Technical Service Bulletin: tsb100236

Released Date: 01-Oct-2003

New Piston Cooling Nozzles

01600121

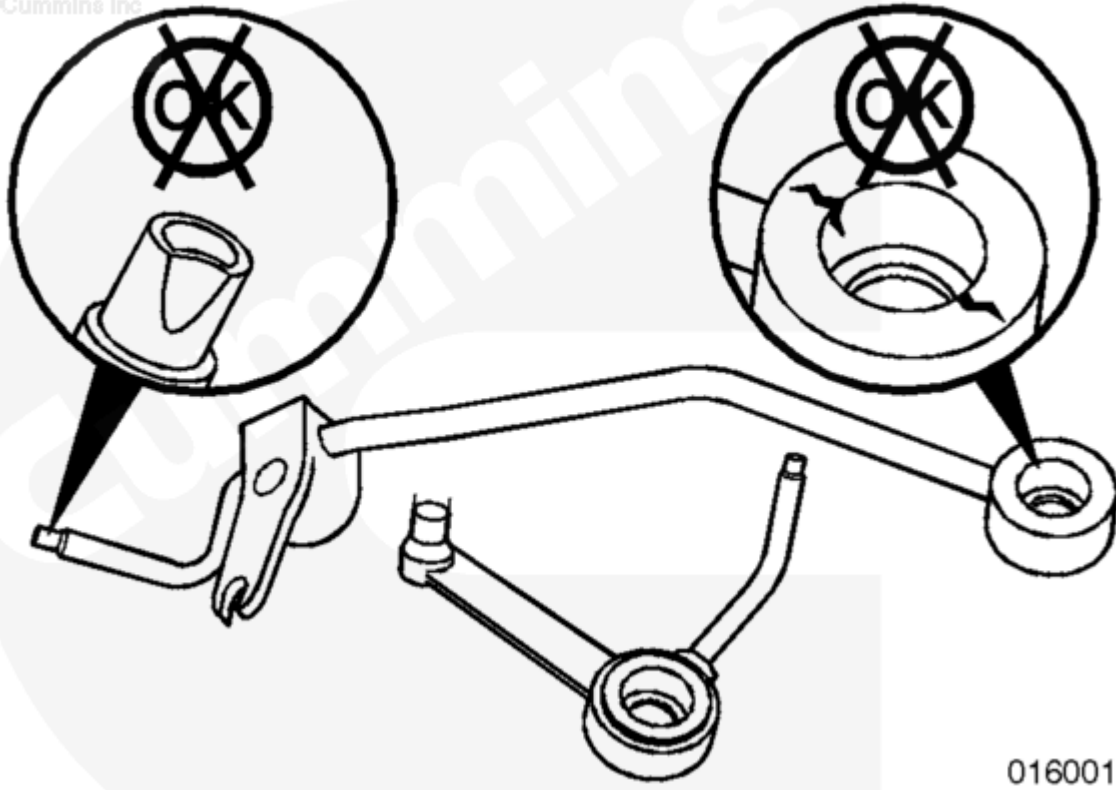
This Technical Service Bulletin introduces a new piston cooling nozzle for the QSK45 and QSK60 engines. The new piston cooling nozzle has been introduced to increase the clearance between the piston cooling nozzle and the crankshaft web.

4100577 is the longer of the two nozzles shown.

Description	Old Part Number	New Part Number
Piston Cooling Nozzle	3411029	4100577
